# PLANNING

Project: 7 Warwick Court

Drawing Title: Proposed Section BB

Drawing No. P\_11 Rev. E

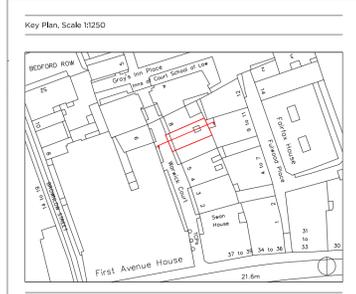
- C. Revision Notes:**
- 1. Front section of roof to be rebuilt.
  - 2. Existing front dormer windows to be retained.
  - 3. Front lightwell windows to be dropped by 400mm.

- 4. Existing wall to be retained.
  - 5. Proposed kitchen.
  - 6. Entrance to Flat 05 to be adjusted to begin in hallway.
  - 7. Door to bathroom from hallway.

- 8. Railings and lightwell stair to remain in existing position.
- D. Revision Notes:**
- 1. Glass screen removed.
  - 2. Kitchen moved adjacent to Flat 03 reception room.

- 3. The addition of demountable joinery with partition and clearestory glazing.
  - 4. New door providing access to master ensuite.
  - 5. Proposed sash windows now french doors.

- 6. Proposed ASHP's now removed.
  - 7. Proposed rooflights reduced in height.
- E. Revision Notes:**
- 1. Flat 04 Bathroom/interior stone layout revised.

- 2. Glazed screen amended to show lightweight joinery partition to separate powder room, bedroom and ensuite.
  - 3. Entrance door to Flat 04 moved towards rear of site by 200mm to allow repositioning of entrance to Flat 05.
